Process Sheet

Customer: CU-DAR001 Dart Helicopters Services

Drawing Name: SKID TUBE ASSEMBLY

DART ENGINEERING ORDER

AMEND DRAWING D2580 REV. C TO ADD D2580-045 ASSEMBLY

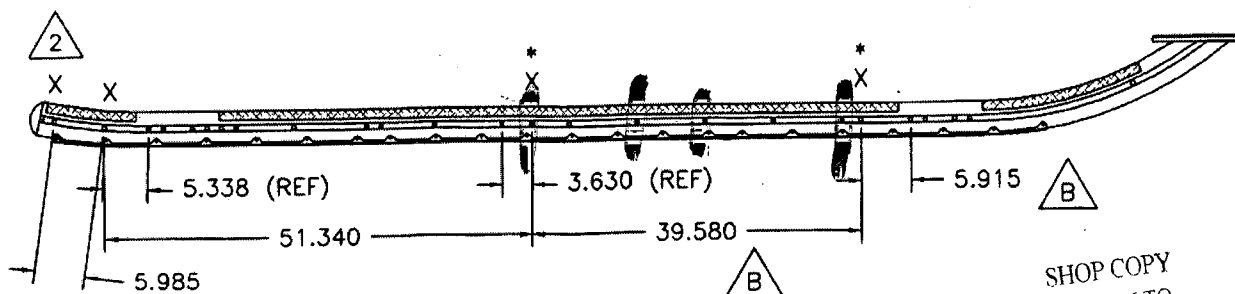
D2580-045 IS IDENTICAL TO D2580-041, EXCEPT FOR THE FOLLOWING CHANGES:

- 1) INSTALL CROSS BOLT SPACERS AT LOCATIONS MARKED 'X' ACCORDING TO THE FOLLOWING PROCEDURE.
 - a) DRILL $\varnothing 0.508$ HOLES AT LOCATIONS SHOWN BELOW MARKED 'X'.
CHAMFER HOLES $0.030 \times 45^\circ$. NOTE THAT HOLES WILL ALSO HAVE TO BE TRANSFERRED TO THE D2596 WEB AT THE * LOCATIONS. IT IS ACCEPTABLE TO PRE-DRILL THE D2596 WEB IN THESE LOCATIONS BEFORE INSTALLING THE WEB IN THE SKIDTUBE. OPEN HOLES TO $\varnothing 0.63$ AND TOUCH UP WITH ALODINE PER QSI 005 4.1.

- b) INSERT D2579 CROSS BOLT SPACERS INTO THE HOLES.
 - c) WELD INTO PLACE PER DART QSI 004 AND GRIND FLUSH.
 - d) REMOVE SPILL OVER LEAVING HOLE DIMENSION $\varnothing 0.380$ - $\varnothing 0.390$.

- 2) IT IS ACCEPTABLE TO GRIND A RELIEF IN THE D2855 AFT CAP TO PREVENT INTERFERENCE WITH THE SPACER AT THIS LOCATION.
- 3) POWDER COAT ENTIRE ASSEMBLY GREEN (REF. 4.3.5.8) PER DART QSI 005 4.3 INSTEAD OF WHITE (REF. 4.3.5.1).
